# CITY OF SAN ANTONIO

Re: Valley View Subdivision (Amendment)

MDP # 789-A

The City Staff Development Review Committee has reviewed Valley View Subdivision Master Development Plan (M.D.P.) # 789-A (Amendment). Please find enclosed a signed copy for your files. Your plan was accepted however please note the following:

70' TYPICAL STREET SECTION  
 SCALE: HORIZ. 1" = 10', VERT. 1" = 5'

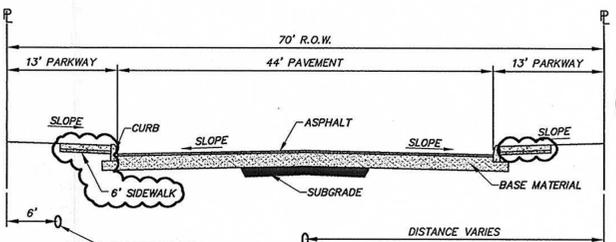
2. Construction of an internal collector street system approximately 1400-feet in length. Collector street design parameters consist of 70 feet of ROW and 44 feet of pavement (Table 506-3). The proposed collector street shall have no houses fronting (UDC 35-515, (c),(4)).

VALLEY VIEW SUBDIVISION  
 PREVIOUSLY KNOWN AS BINZ ENGLEMAN SUBDIVISION  
 MASTER DEVELOPMENT PLAN

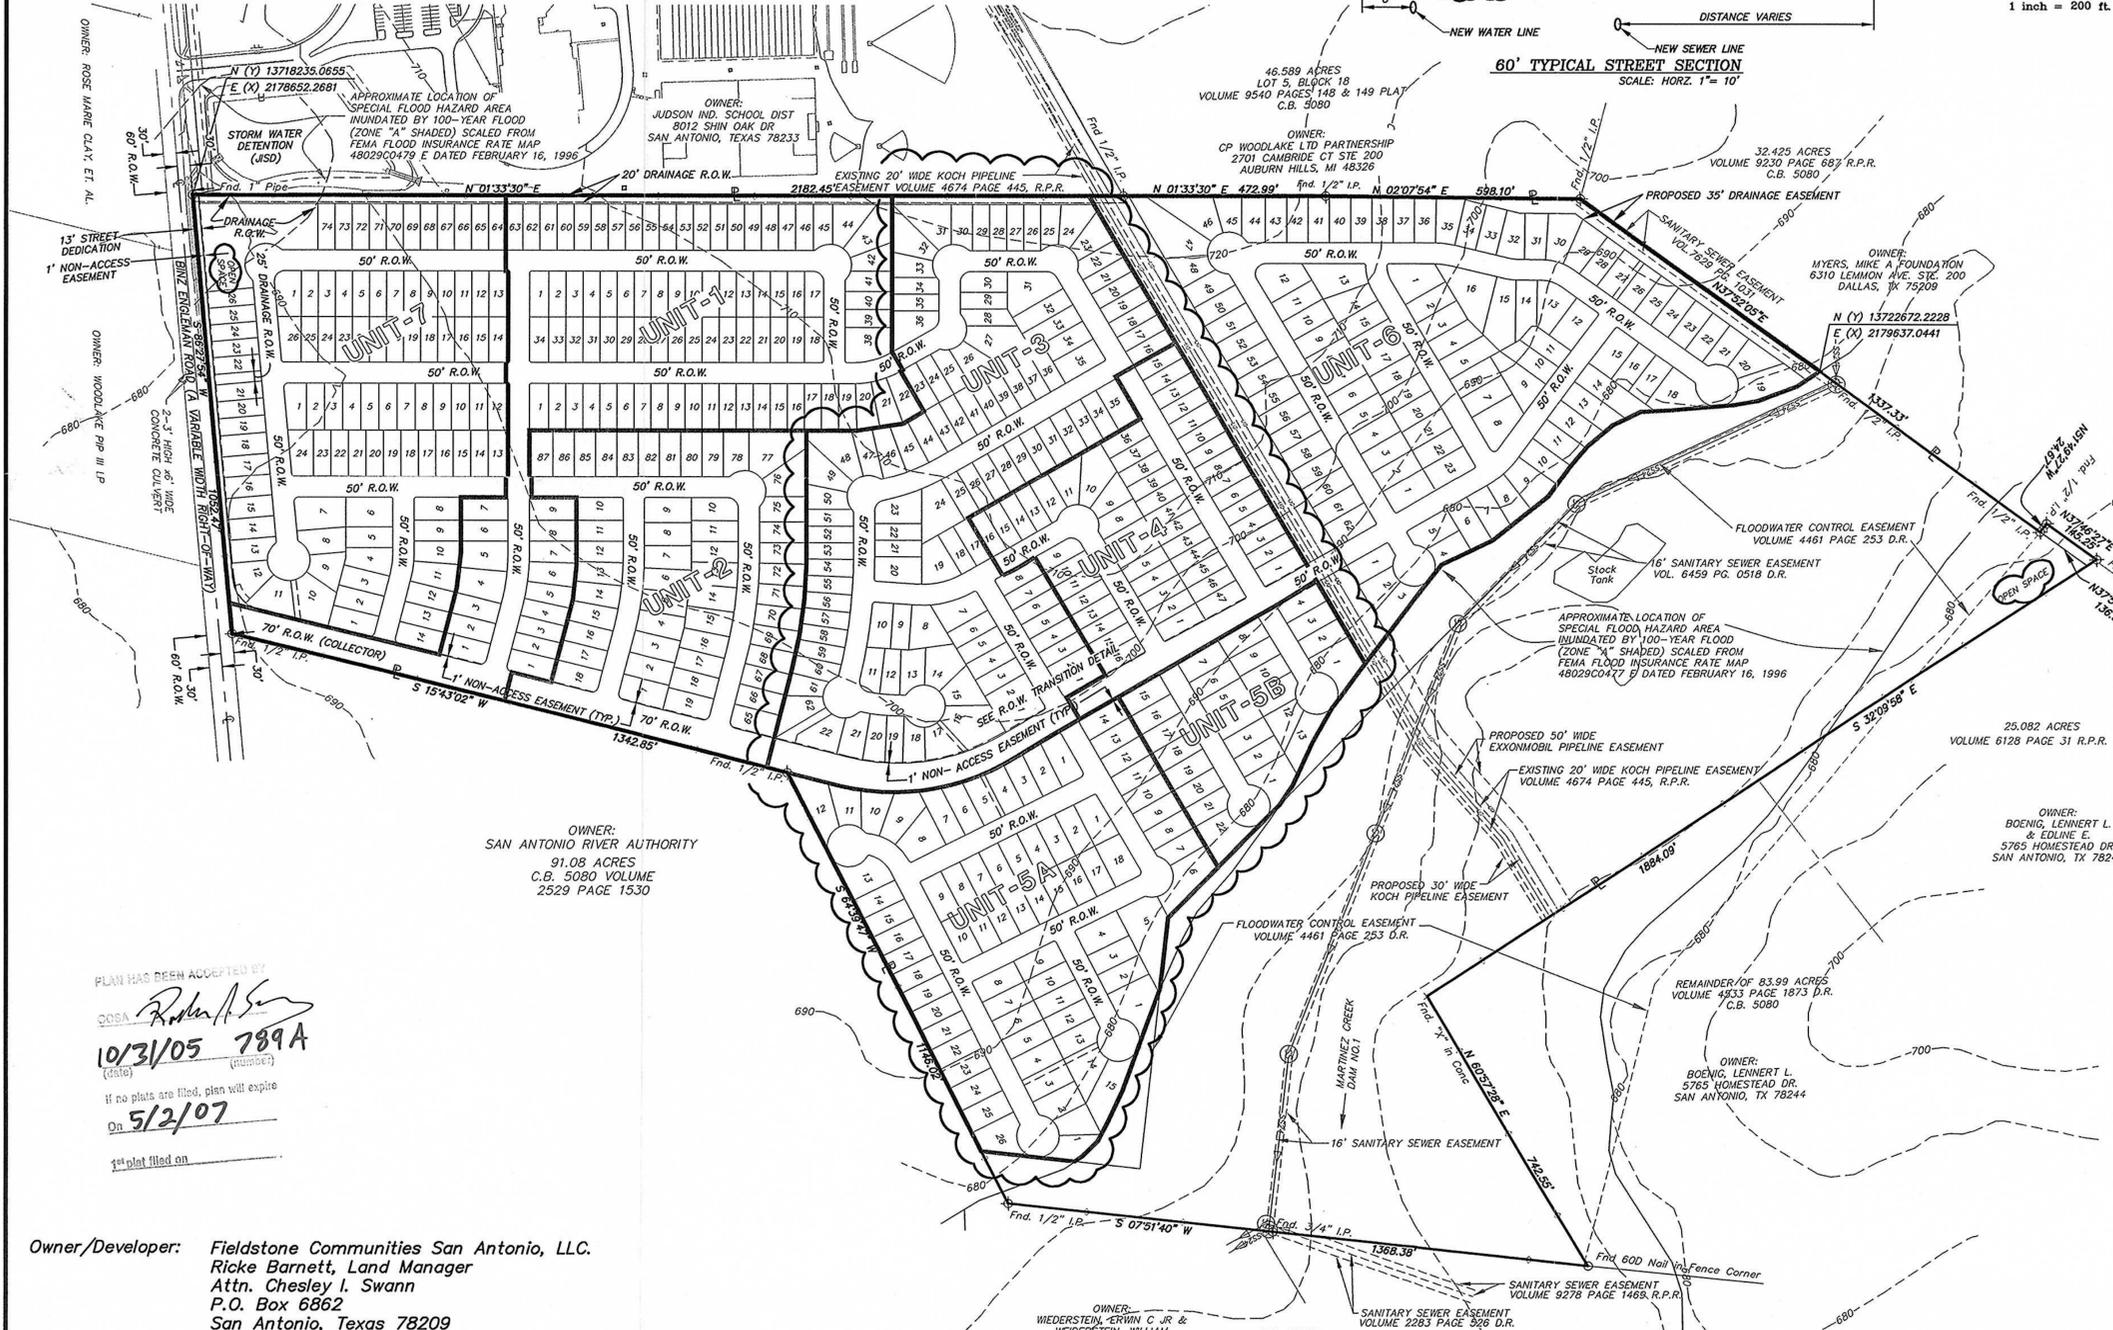
- Development Service Planning as part of the conditional approval, cite at the time of platting Unit-6 shall satisfy this section of the City of San Antonio Unified Development Code (UDC) by the following means:

1. Provide and construct the street stub-out and drainage culvert in accordance with the UDC or
  2. A variance request to section 35-506, (e) Connectivity, (2) Projecting Streets before the Planning Commission.

- The Development Services Engineering (TIA) as part of their conditional approval cite the following, on-site improvements, as well as, improvements along the project limits are necessary and shall be provided by the developer at the time of platting for Valley View Development, at no cost to the City Of San Antonio.

1. Binz-Engleman Road- The Developer shall dedicate 43 feet of ROW (Ordinance 98282, October 2, 2003 Major Thoroughfare Plan (MTP)) from the centerline of Binz-Englemen Road (Secondary Arterial Type A – Uniform Development Code (UDC) 35-506, (g), (2) adjacent to this proposed project. The total length of property frontage is 1052.47- feet as indicated by submitted MDP.

3. Construction of an internal Local B Street approximately 1200-feet in length from the end of the proposed collector to Unit 6 (UDC Appendix A, Definitions of Local A and Local B).
